DEPARTMENT OF THE NAVY

MEMORANDUM

**PROPOSED REMEDIAL ACTION PLAN  
FOR  
SITES 1, 2 & 3  
NWIRP BETHPAGE, NEW YORK**

COMMENTS AND NAVY RESPONSES  
ON  
PROPOSED REMEDIAL ACTION PLAN - SITES 1, 2, 3  
NWIRP BETHPAGE, NY

**FIGURE 11**

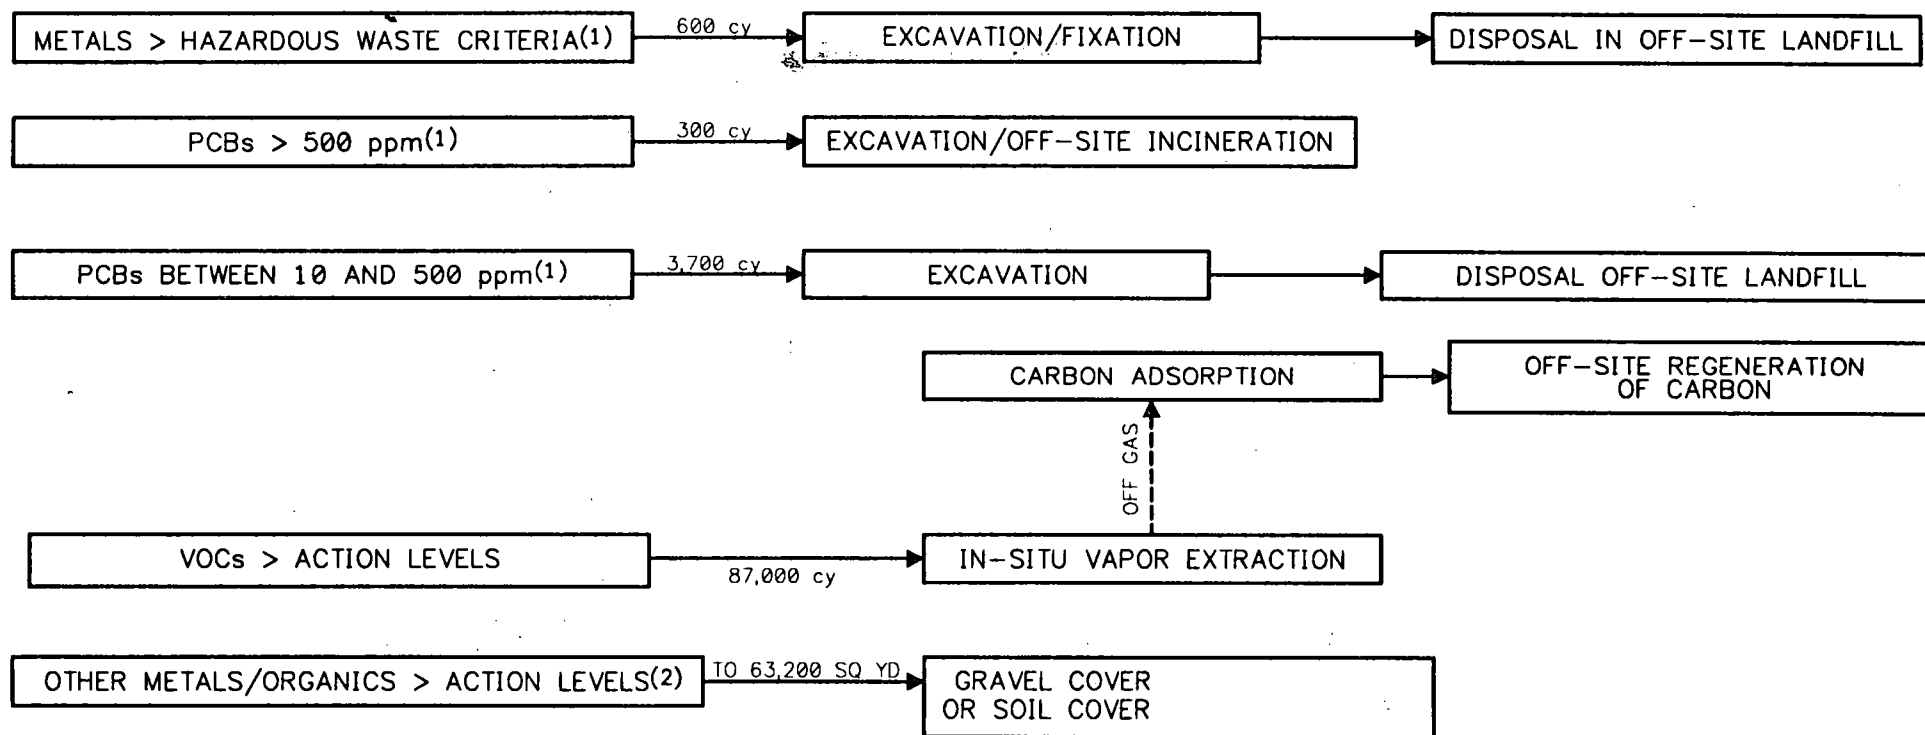
1. Comment: Alternative S7, which is the proposed remedial action at the site, "consolidates and caps" PCB contaminated soil with a range of 10 to 50 ppm on site. We would prefer the use of alternative S6 which provides for the removal of these soils and their landfilling off site. Leaving these soils on site, even though consolidated and capped, provides a possible source of contamination in the future in an area designated as a sole source aquifer and the possibility that additional remedial action would have to be taken in the future.

Figure 11 shows a diagram illustrating the steps associated with Alternative S6. Table 3 shows the chemicals of concern at each site and their associated proposed action levels (see Table 1, pages 23-26). This table also illustrates which part of the preferred alternative is to be used to address each chemical. In summary, the main elements of the preferred alternative are:

Response: This opinion was shared by other TRC members including the Naval Air Systems Command, owners of the property. Therefore, Alternative S6 has replaced S7 as the preferred alternative.
